Service Bulletin

S.B. No: 189

Title: INSPECTION OF TAILPLANE ATTACHMENT BOLT THREAD DIAMETER

Applicability: T67B, T67C Series, T67M, T67M-MkII, T67M200, T67M260 & T67M260-T3A with Slingsby bolt batches G208350 and/or G208351 installed.

FIGURE 1
M5 BOLT THREAD MAJOR DIAMETER

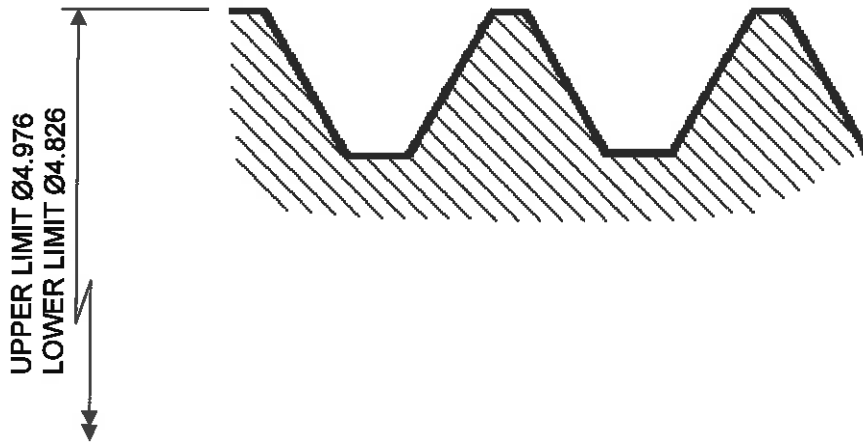
This Service Bulletin is raised to cover an incident where the forward attachment bolt holding the tailplane to the fuselage did not torque correctly. The bolt was removed and inspected, the major thread diameter was found to be below the lower tolerance limit. Bolts in stock were then checked and approximately 90% were found to be undersize.

The bolts affected are part no. T67B-08-527 Slingsby batch number G208350 and part no. T67B-08-529 batch number G208351.

1. Check forward and aft tailplane bolts have had the correct torque applied, refer to relevant aircraft's Maintenance Manual.
2. If torque has not been achieved remove and return bolt/s to SACL.
3. Prior to fitting new bolts check major diameter, acceptable dimensions are: upper limit 4.976mm & lower limit 4.826mm, Figure 1 refers. Any bolt not meeting these limits is to be replaced with correct diameter bolt. If in doubt do not fit bolt return to SACL.
4. Return all bolts held in stock and any other bolt not meeting the dimensions, to SACL Customer Support Department for replacement.
